Service Bulletin

Model #	No.	Date
Neptune r1.3 (Sept 2024)	002	10/06/25

While using the Neptune r1.3 (Sept 2024) and earlier, the console may hang with a black screen after displaying the TMSS message when powered on.

Component Locations

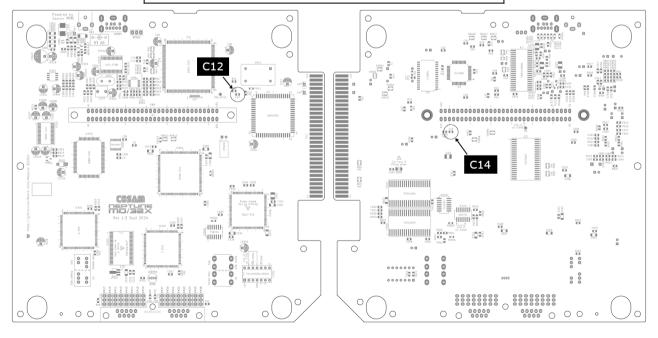
It has been found that the values of capacitors C12 and C14 may be too high to allow a proper power-on reset in some edge case situations.

Capacitors C12 and C14 must be replaced with value 1nF to fix this problem, see COMPONENT LOCATIONS below.

1.	Remove capacitors C12 and C14 (see diagram).
2.	Fit size 0805 capacitors with value 1nF at C12 and C14.
